**Southern
Water**

Your ref
Y/105/19/PL

Proposal: Conversion of & alterations to existing barns to create 3 no. dwellings, erection of car barns & stores, a replacement pump house, demolition of barn & associated landscaping & parking - This application may affect the character and appearance of Main Road/Church Road Conservation Area.

Site: Y/105/19/PL: - Stakers Farm, North End Road, Yapton, BN18 0DU.

Southern Water MapGuide Browser

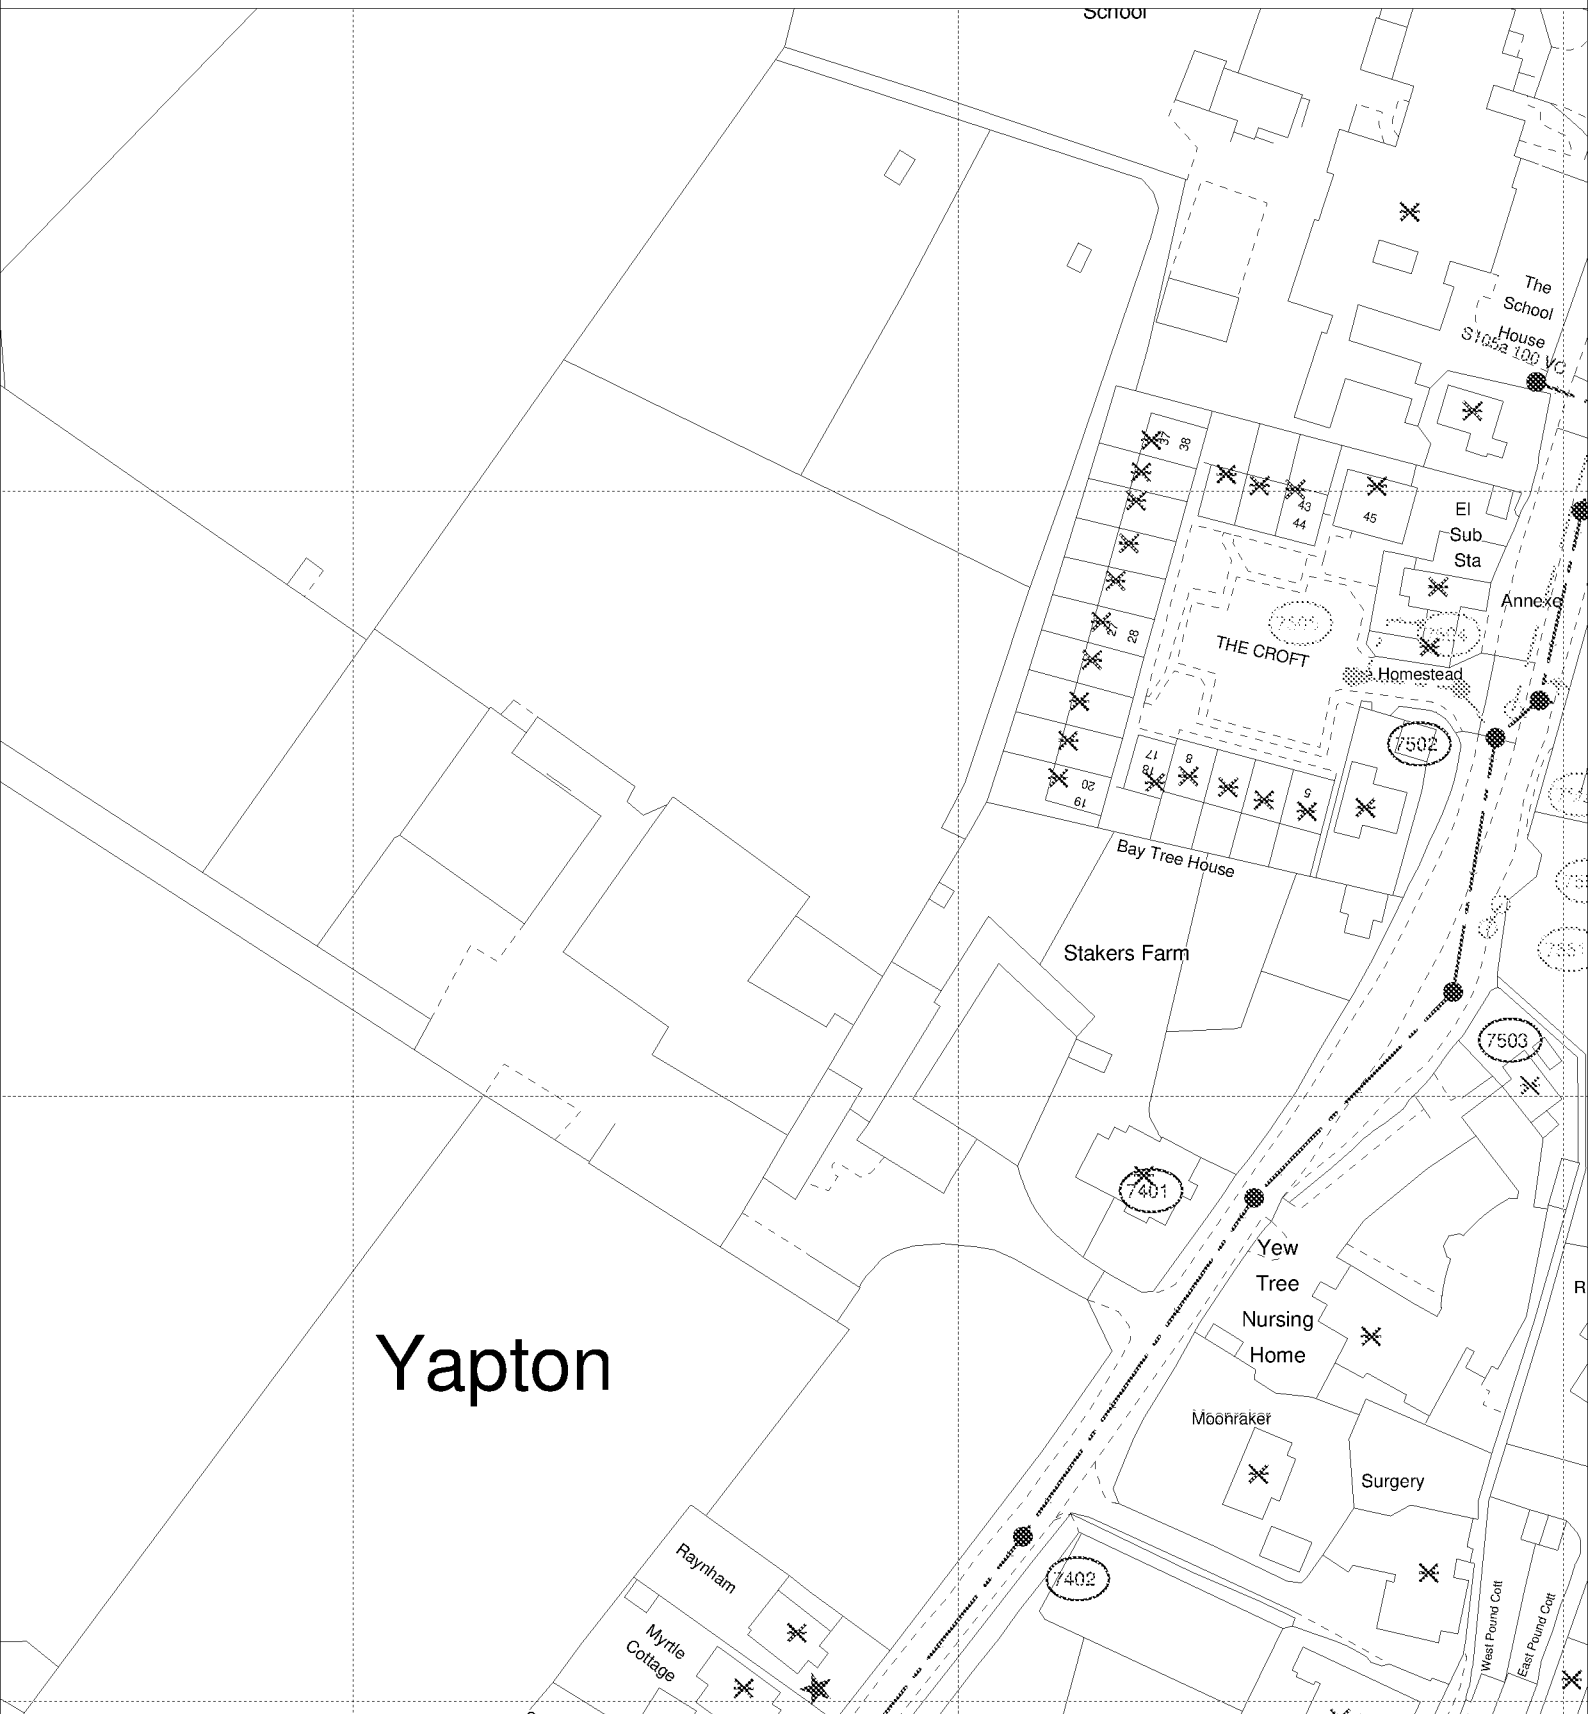
It is possible that a sewer now deemed to be public could be crossing the development site. Therefore, should any sewer be found during construction works, an investigation of the sewer will be required to ascertain its ownership before any further works commence on site.

Due to surface water inundation issues in the Lidsey Catchment the applicant is advised to adopt, where appropriate, the measures in the table "Practical measures to reduce the potential impacts of development". Developer should look to protect the public sewerage system from inundation and infiltration, which contribute to flooding in unfavourable conditions.
